Friday, December 03, 2004

In response to your letter regarding the water metering and control in Croy Creek, I submit the attached plan for a metering device. This device was designed during a meeting with Kevin Lackey as proper for our diversion and we will implement it on or before June, 2005.

PROPOSED MEASURING DEVICE

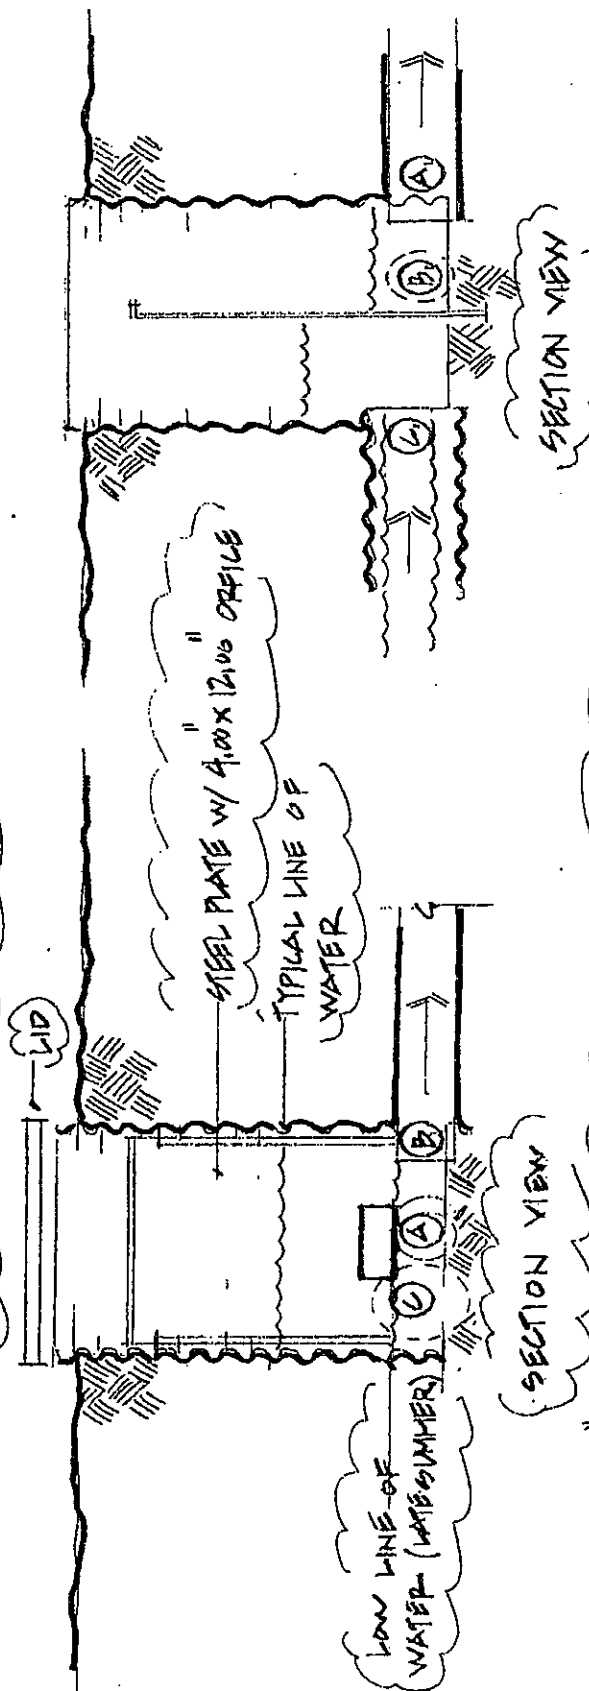
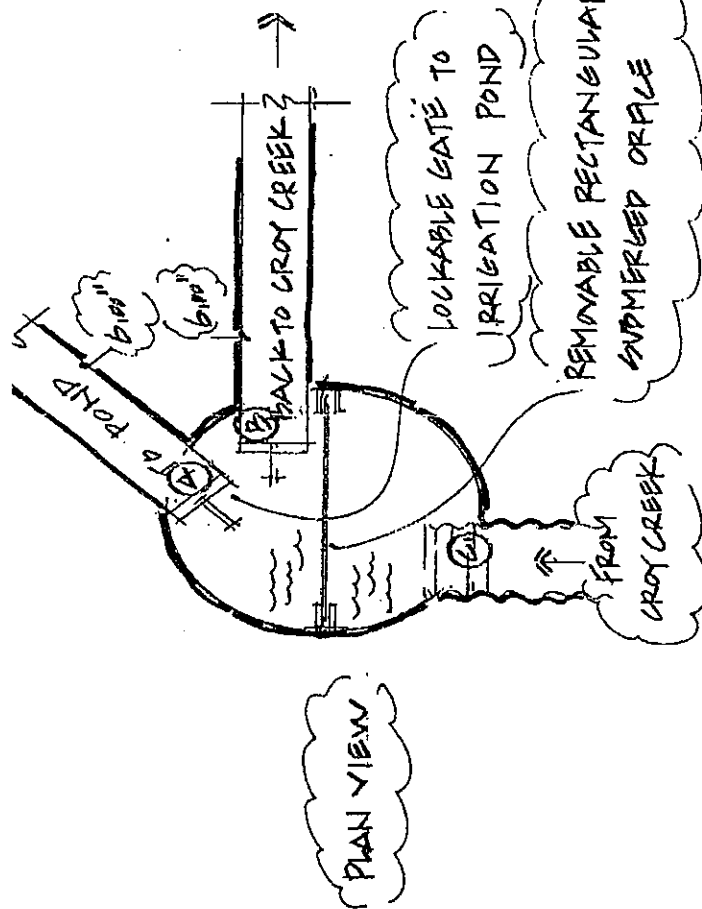
1. Seems weird that pipe B is downstream of orifice. L2Key indicated that he would charge based on anything measured thru orifice whether it goes to pond or creek.
2. Need to have ^{orifice} weir plate sealed so no water passed under or around plate. (since this will be against cmp seal may be tricky)
3. Need gauge on upstream & downstream side of orifice.
